D e s i g n R e v i e w
B o a r d

S t a f f R e p o r t

312 Rheem Boulevard

DRB-12-11 to allow construction of a new five and one-half foot (5½') tall wood fence, pedestrian gate, and black metal vehicular gate along a scenic corridor. The fence would be located approximately one foot (1') from the front property line. The top one foot (1') of the fence would be vertical wood lattice, and the bottom four and one-half feet (4 ½') of the fence would be solid wood. The vehicular gate would be located at the driveway nine feet (9') from the front property line. (2-DUA, K.S.)

Figure 5:

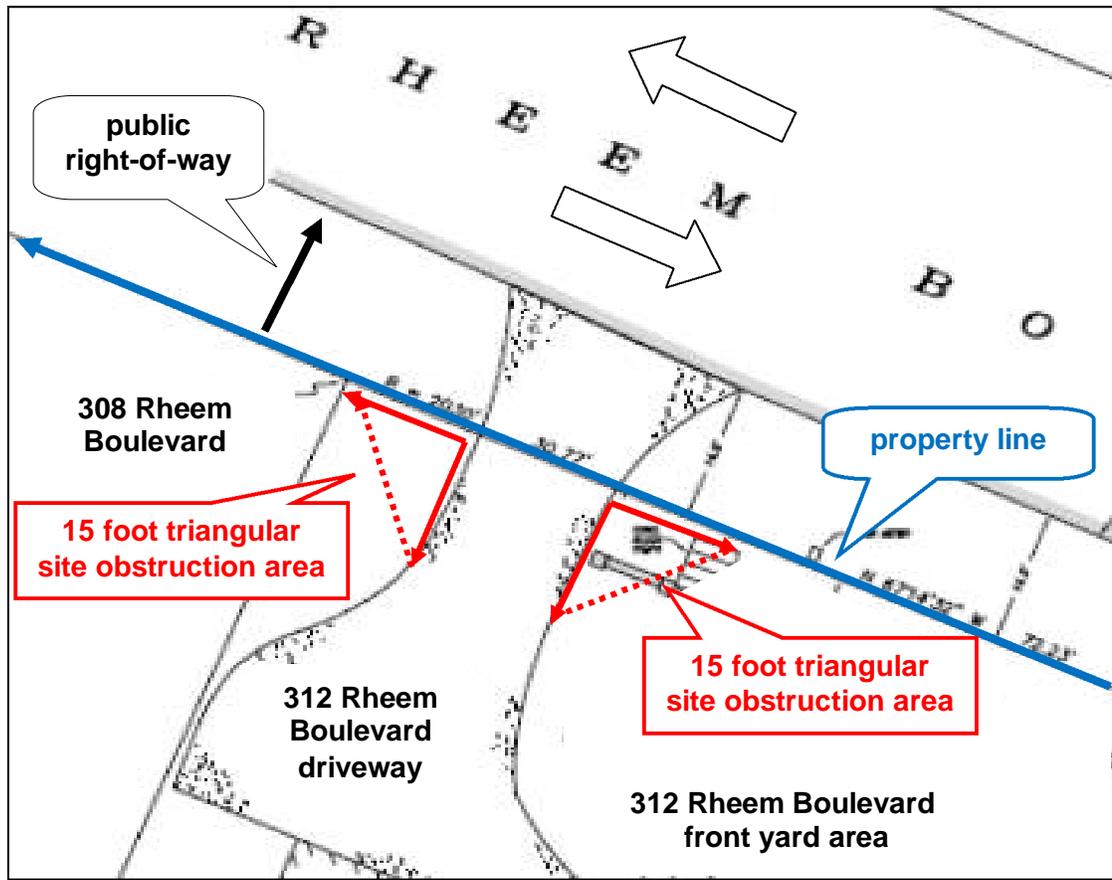
3. Sight Obstructions: MMC §8.80.010(B) states that visibility is obstructed if a sign, fence, structure or vegetation is higher than three feet (3') and located within the 15-foot triangular sight obstruction area at the intersection of a street and a driveway (Figure 5). The proposed fence would be more than three feet (3') in height and located within the 15-foot triangular sight obstruction area at the intersection of the street and driveway. Visibility would not be obstructed in this 15-foot sight obstruction area if the fence tapered to 3 feet in height or was more permeable. In the public right-of-way, there is a large pine tree on the right side of the driveway and a clump of tall trees on the left side of the driveway, all of which are located in front of the 15 foot triangular sight obstruction area.
